STAFF REPORT

Subject: Jerde Single Family Dwelling Addition; 192 Foothill Drive; Zephyr Cove, Douglas County, NV; Assessor's Parcel Number (APN) 1318-10-310-045; TRPA File Number ERSP2023-0906

DRAFT PERMIT

description

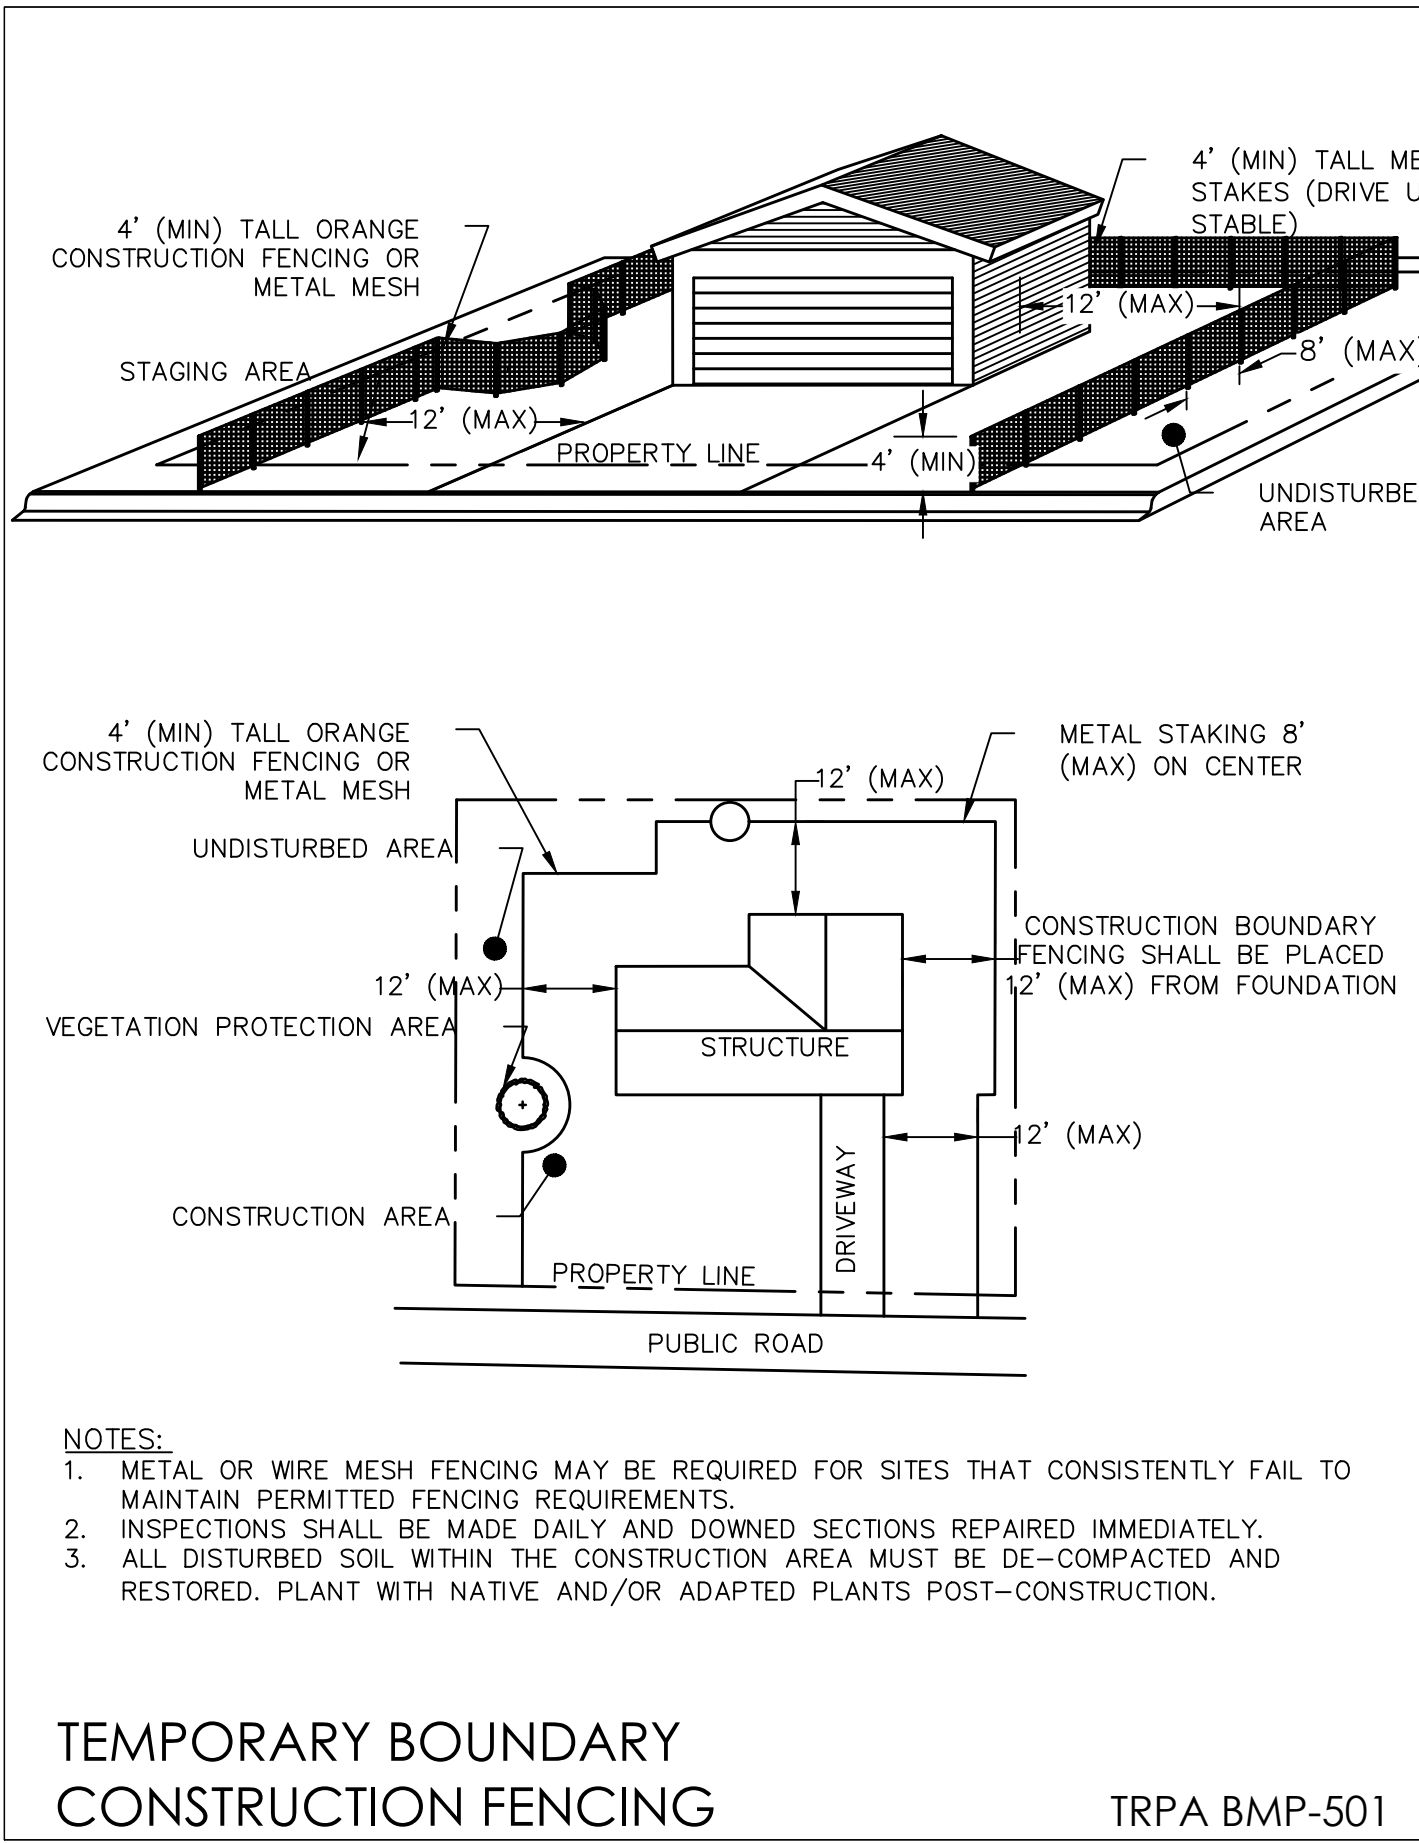
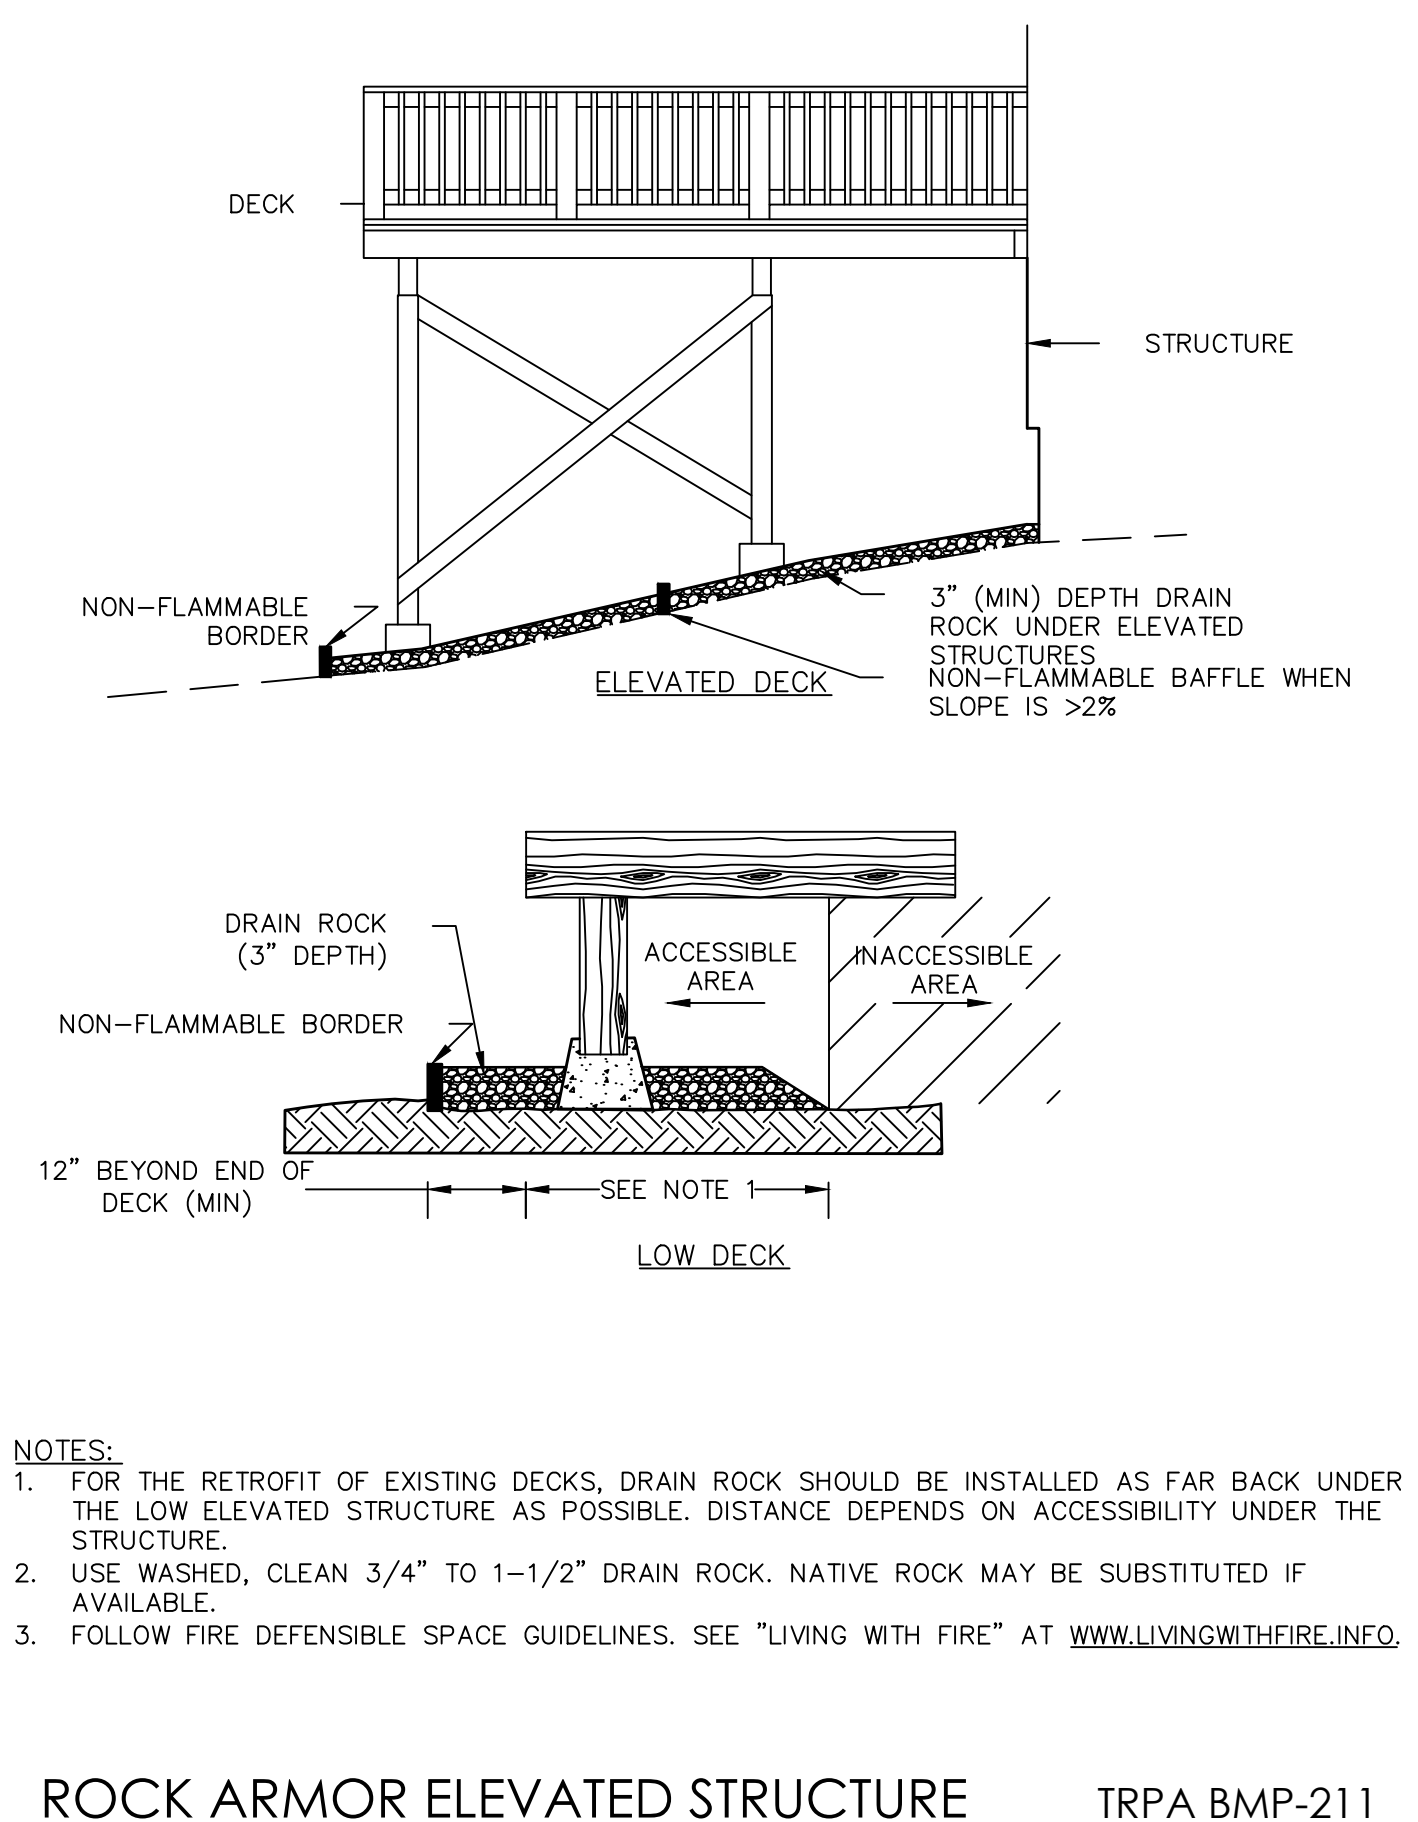
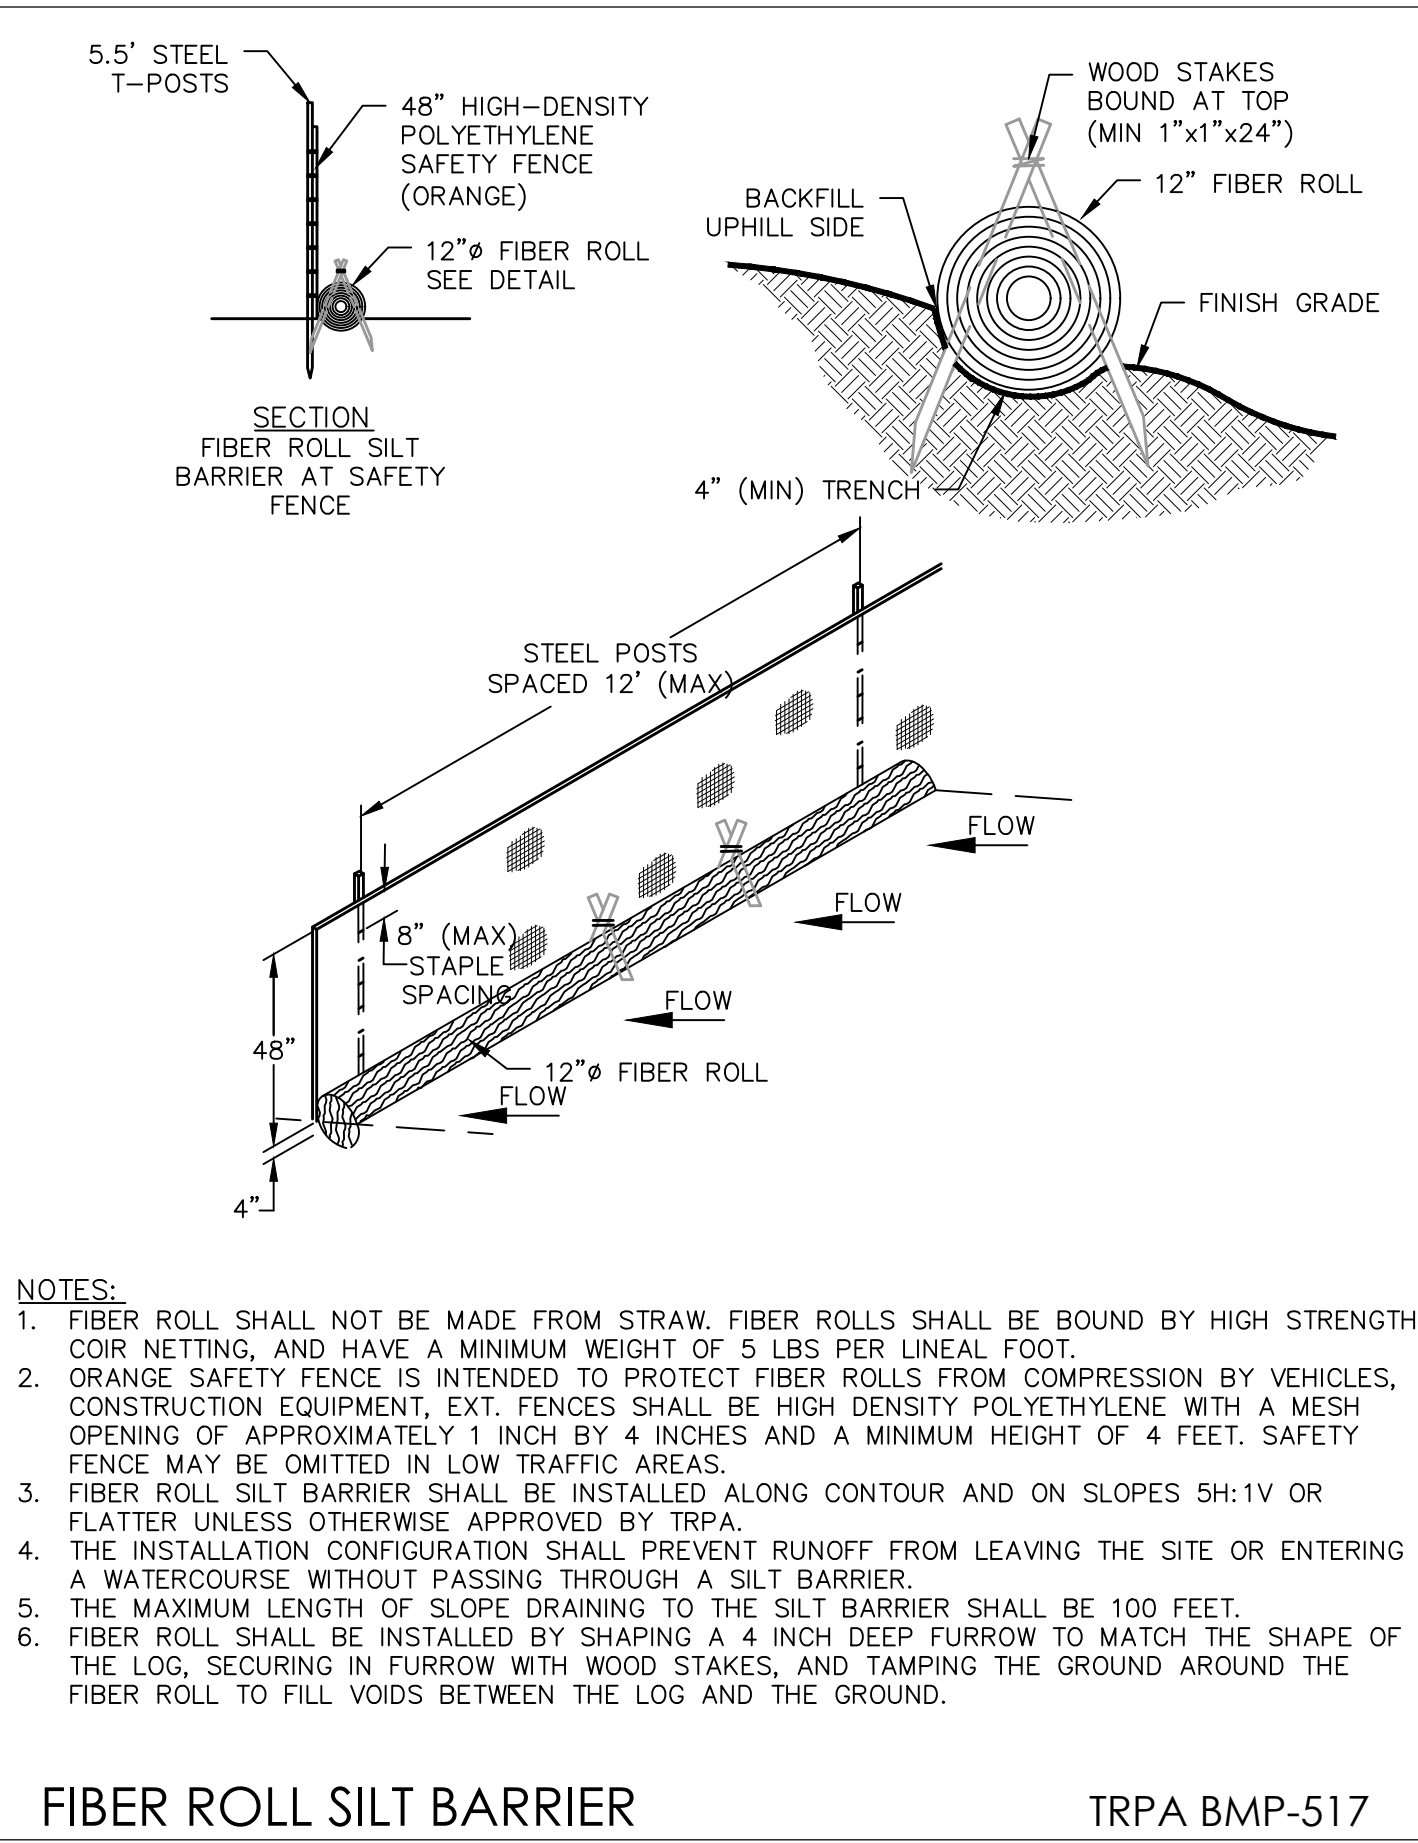
2. The Standard Conditions of Approval listed in Attachment R shall apply to this permit.
3. Prior to permit acknowledgement, the following conditions of approval must be satisfied.
 - A. The site plan shall be revised to include:
 - (1) The following revised proposed land coverage calculations:

Main House	900 sf
Deck w/3:1 Height Reduction	370 sf
Wood Platform & Steps	192 sf
Shed	120 sf

Concrete Pad/Patio	76 sf
<u>Concrete Driveway</u>	<u>690 sf</u>
Total Proposed Coverage	2,348 sf
Banked Coverage	251 sf
Remaining Potential Coverage	491 sf

- (2) Slope calculation across the building site, as described in TRPA Code Section 37.3.3 and Figure 37.3.3-A.
 - (3) Location and elevation of the proposed low point of the structure for calculation of proposed height.

- (4) Location of all existing/proposed utility lines.
 - (5) No trees are approved to be removed with this project. Revise plan to remove indication of trees to be removed.

- (6) Proposed permanent BMPs and BMP infiltration calculations for the existing shed and tent platform.
 - (7) Vegetation protective fencing around the entire construction site. The fencing shall be no more than 12 feet from any footprint, driveway, or area of approved disturbance. Trees located within the construction area that are to be retained shall be individually protected by fencing beyond the drip-line of the outermost branches, or by other means if approved by the TRPA Inspector. No equipment, personnel or disturbance is allowed within the areas protected by the vegetation fencing.

- (8) Parking barriers to restrict parking to approved parking surfaces only.
- B. The elevations shall be revised to include corrected allowed and proposed height calculations based on the revised slope across the building site and the identified new low point of the structure.
